# ADDENDUM 3

**PROJECT:**  
(IFB) #R-17-002-201  
**MIDDLE STREET OFFICE RENOVATIONS**  
City of Chattanooga

**ADDENDUM NUMBER:** 3

**DATE:** 10.10.17

A1-0

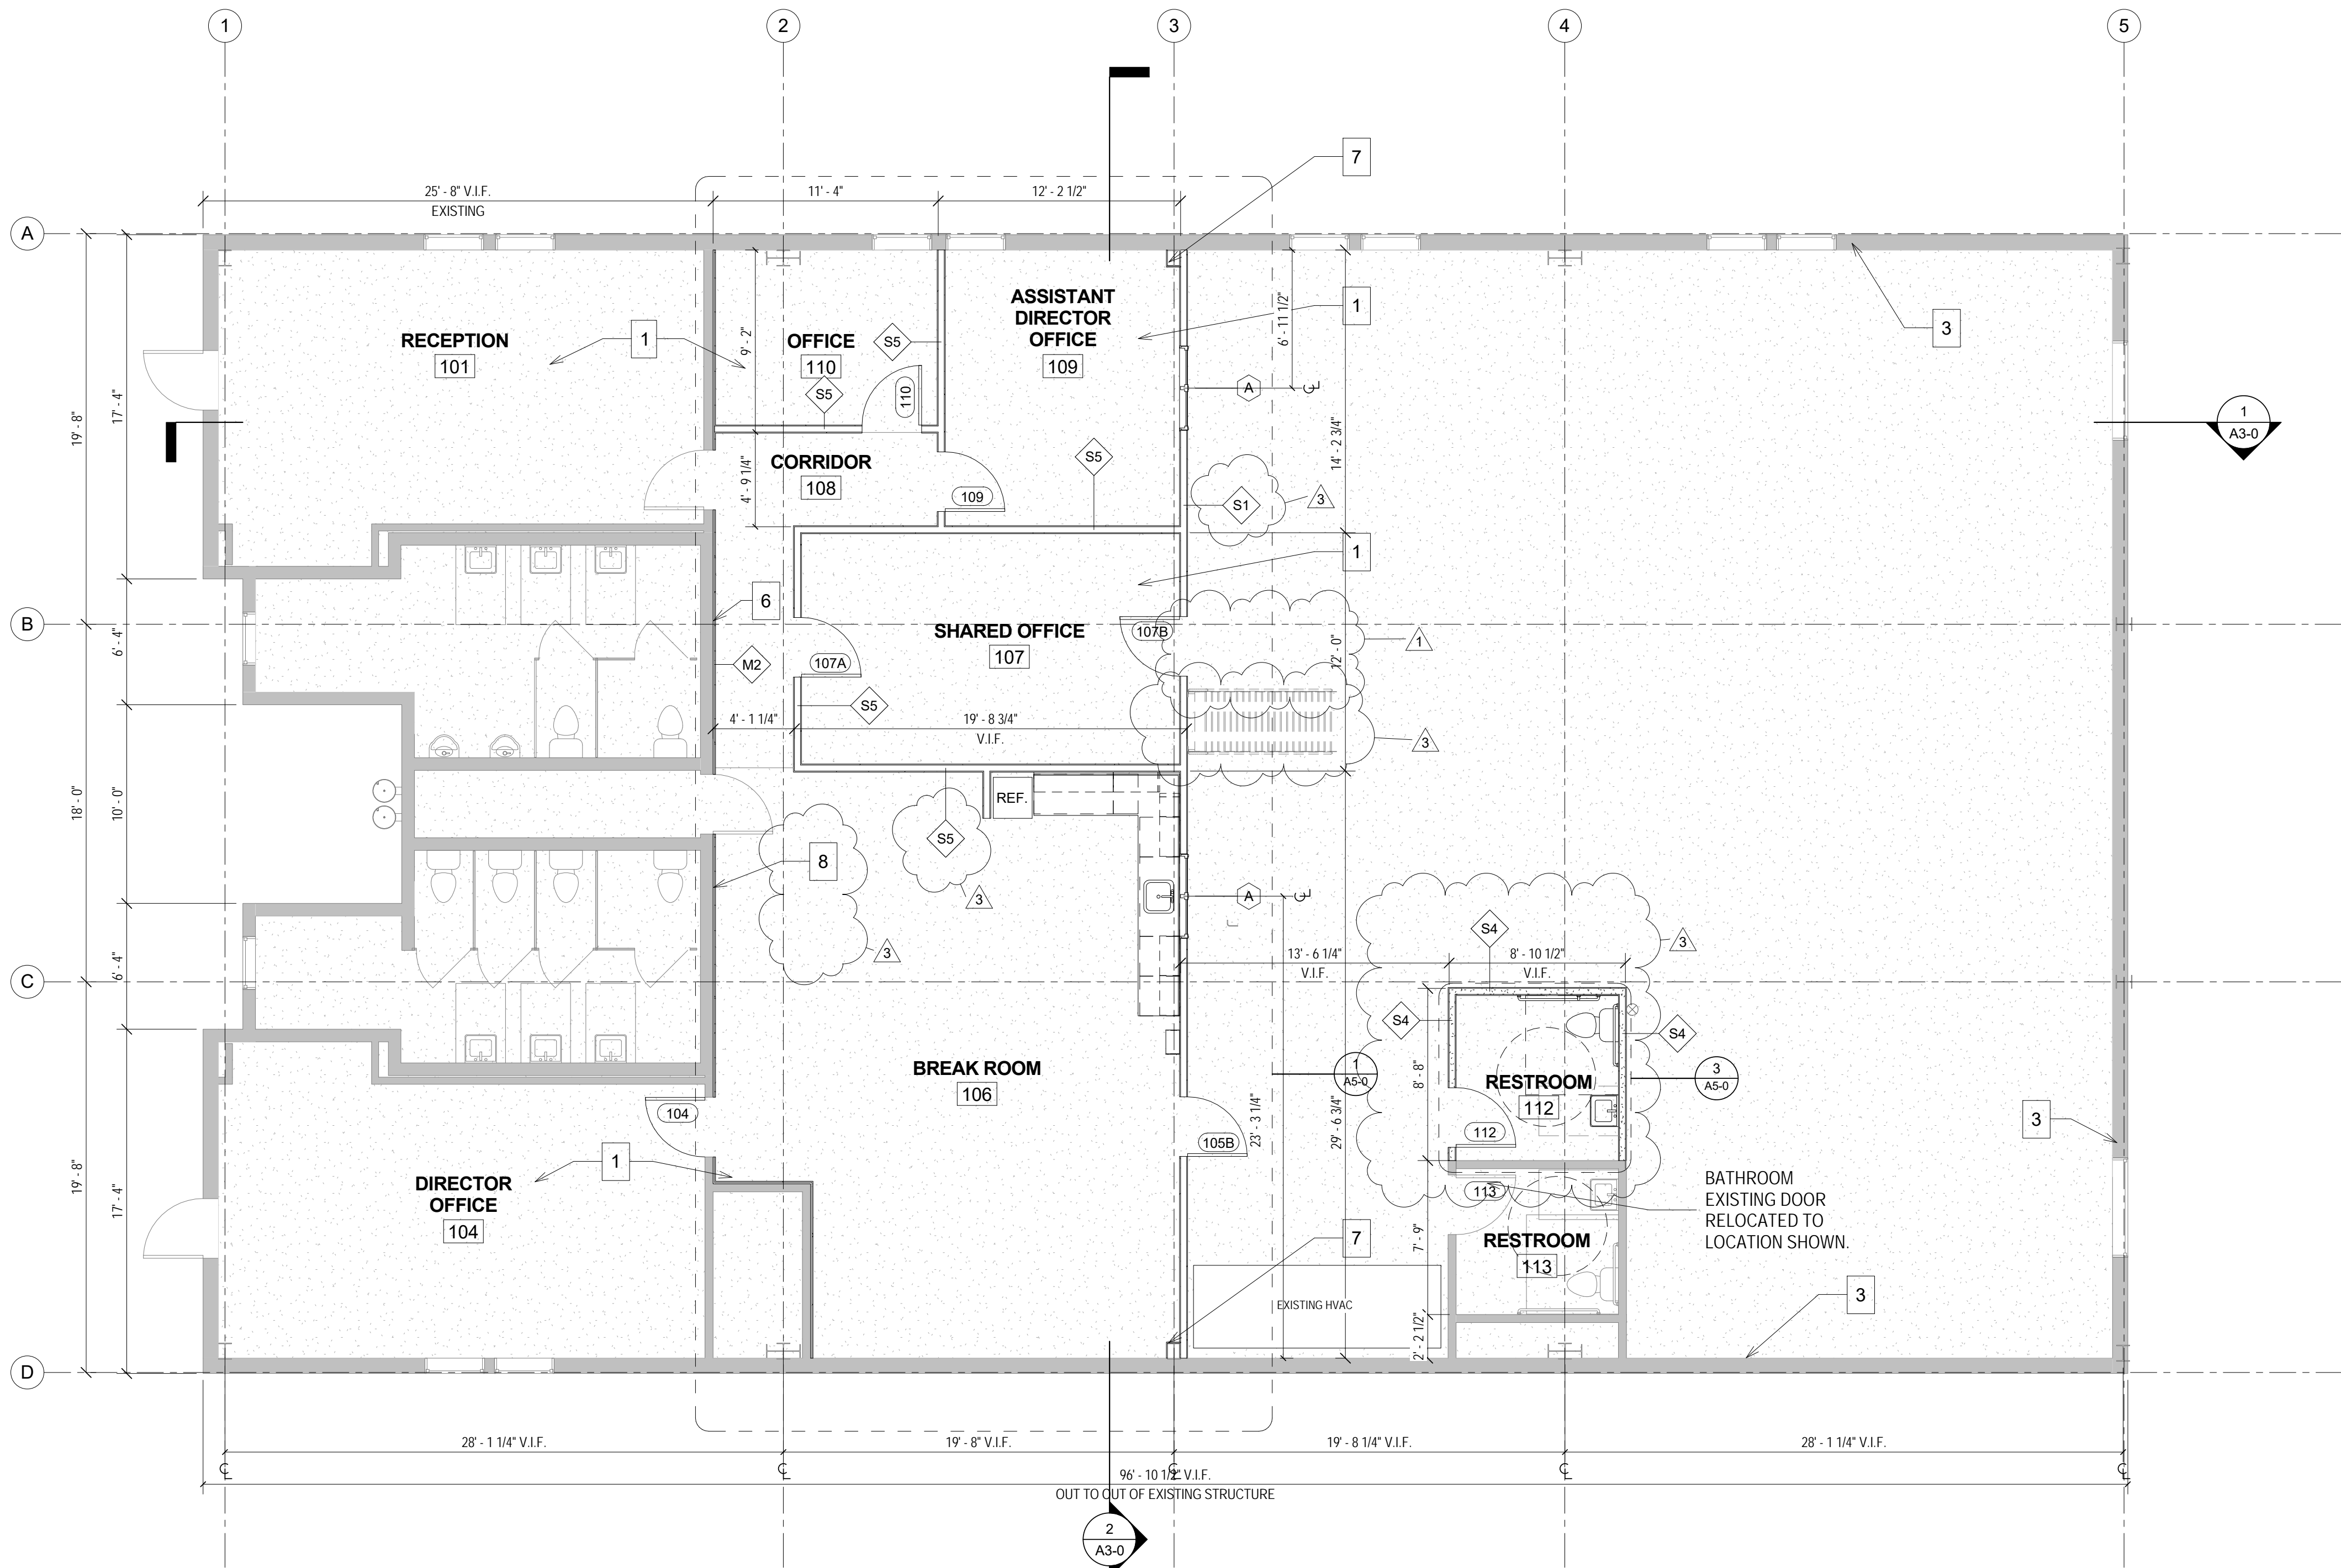
1. QUESTION: "In restroom 112 the left and upper wall are drawn different than the S6 wall. What type of wall construction are they?"
  - a. ANSWER: Wall types for restroom 112 have been clarified on A1-0; they should be non-rated 3 5/8" metal stud walls with sound-attenuation insulation extending 6" above ceiling.

2. QUESTION: "Per Sheet A1-0 the new Restroom wall is called out to be type S6 which is to terminate at the deck. The existing restroom walls do not extend to the deck. Are we to build the new walls to the deck or stop at same height as existing walls? If So - Do we extend the existing walls to the deck? Please advise."

- a. ANSWER: Scrape and paint existing block in this area. Ref. revised notes on A1-0.
11. QUESTION: "Please reference the above photo how do you want to address soffit as it comes across existing room and how should we address conduits on wall to electrical panels?"

SHEET A1-0 has been modified as follows:  
Keyed note added and items noted changed  
Wall types changed at restrooms, center dividing wall, offices  
Ship ladder has moved

- a. ANSWER: Wall types for restroom and other walls have been clarified. The only walls extending to the deck are the dividing wall extending all the way across the space and the attic walls, called out as S1.

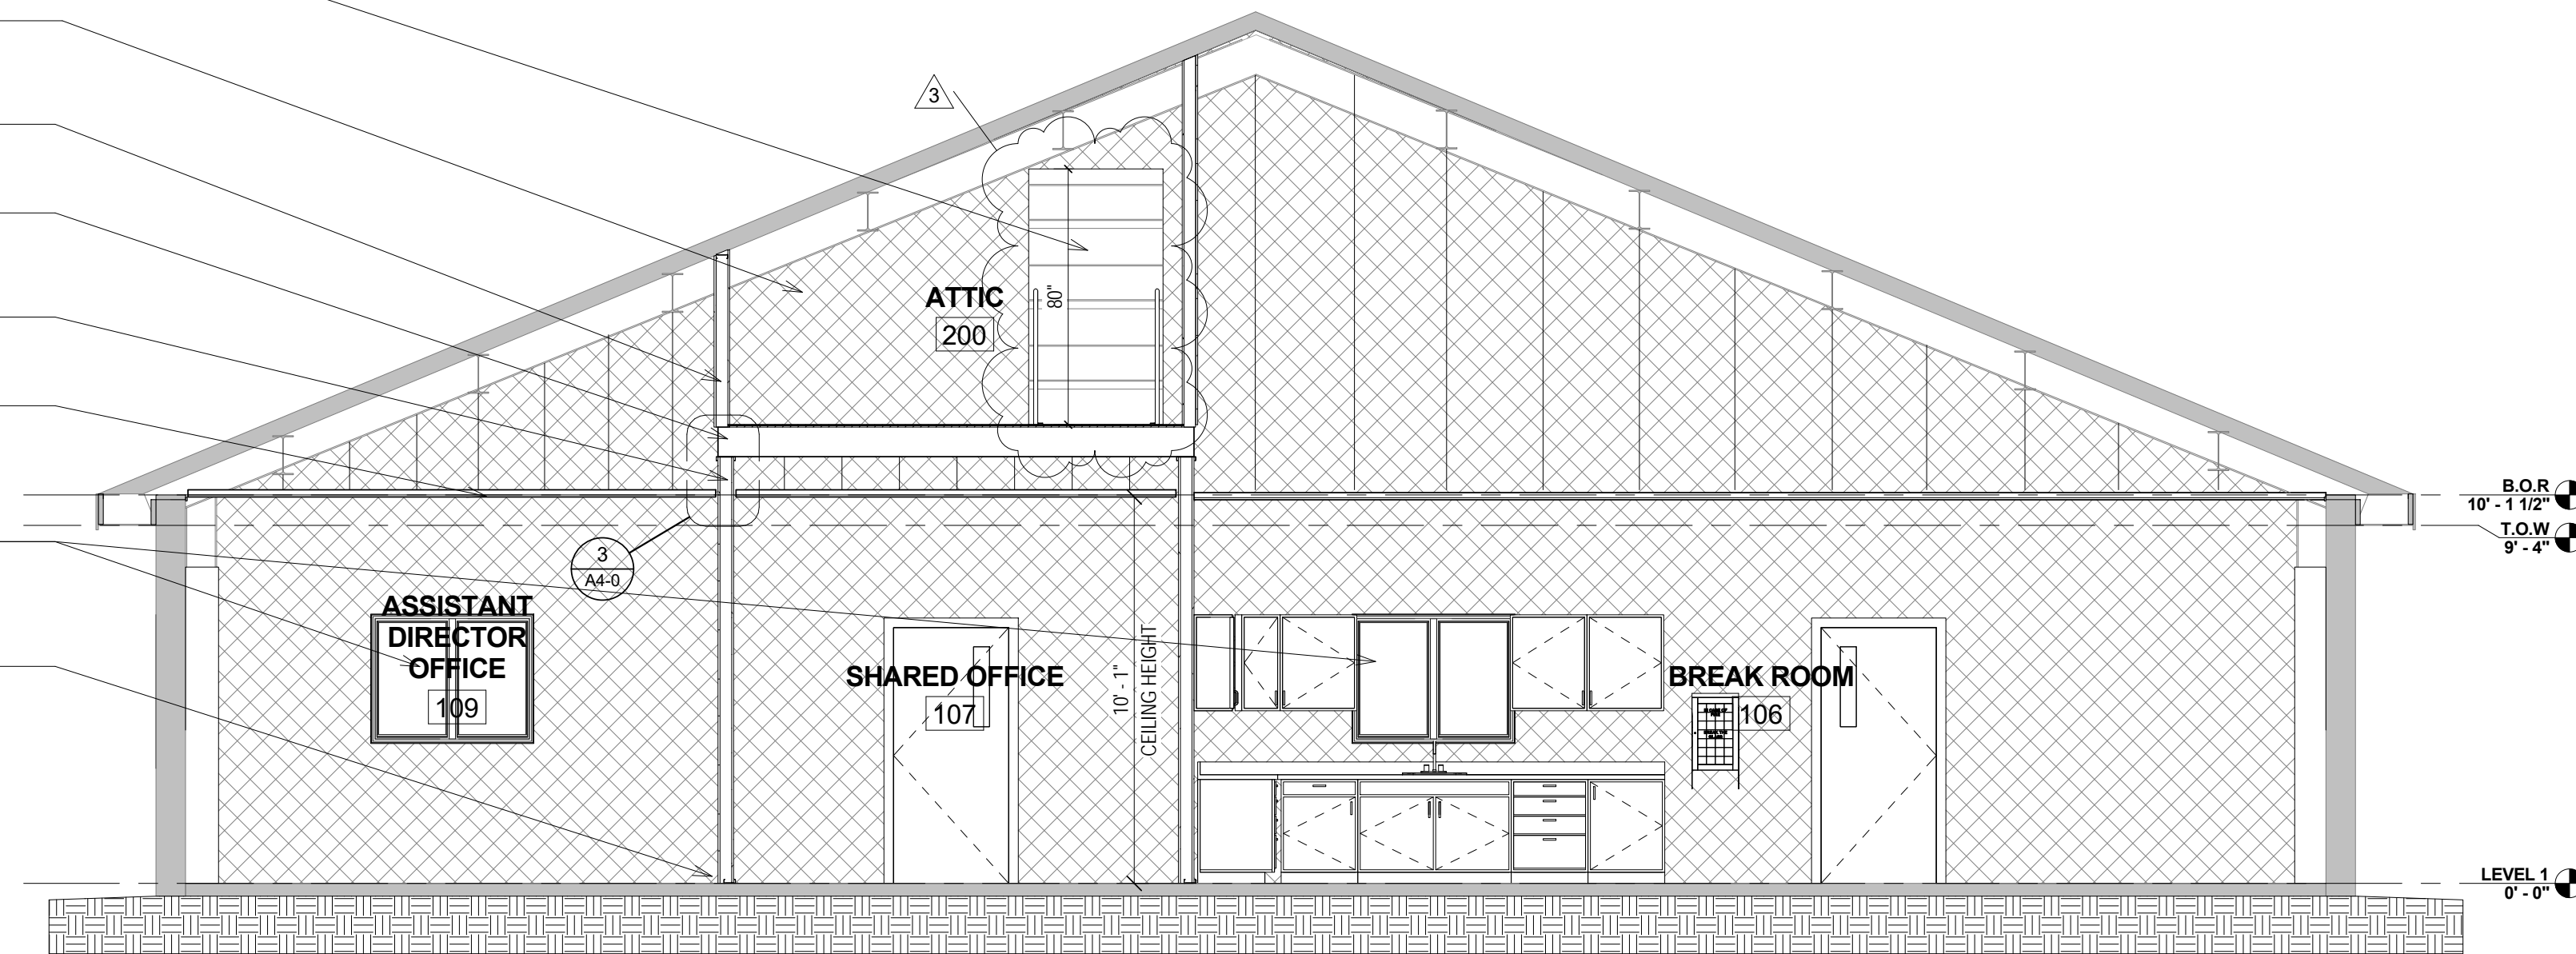
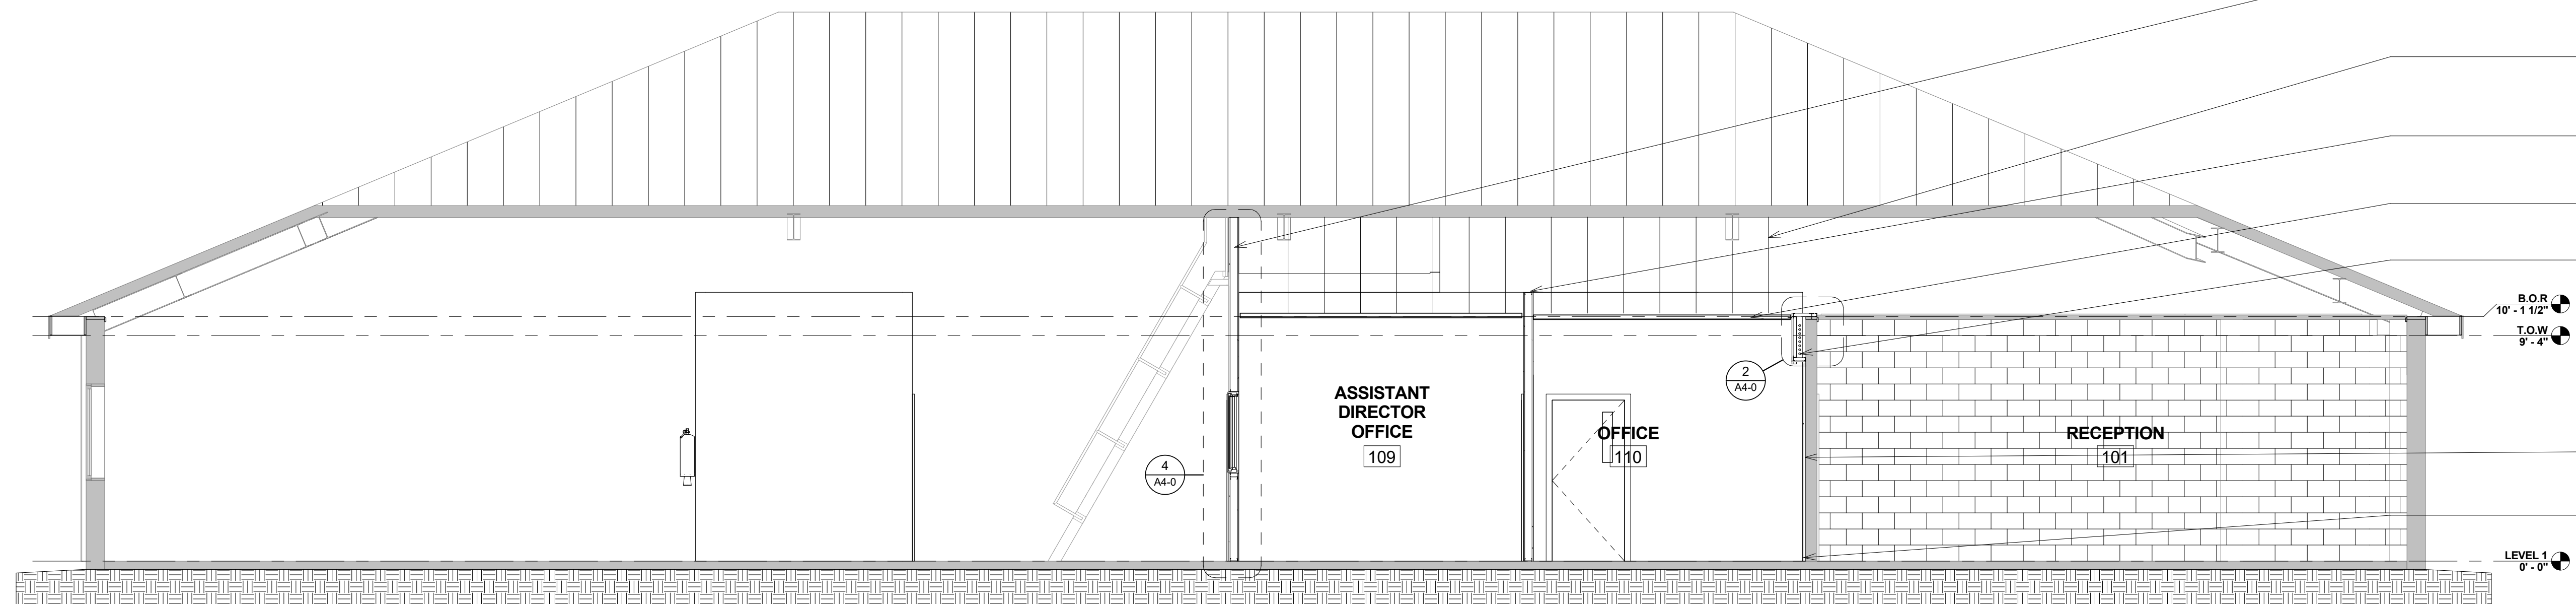
Walls at attic were extended to deck

Attic door replaced with opening
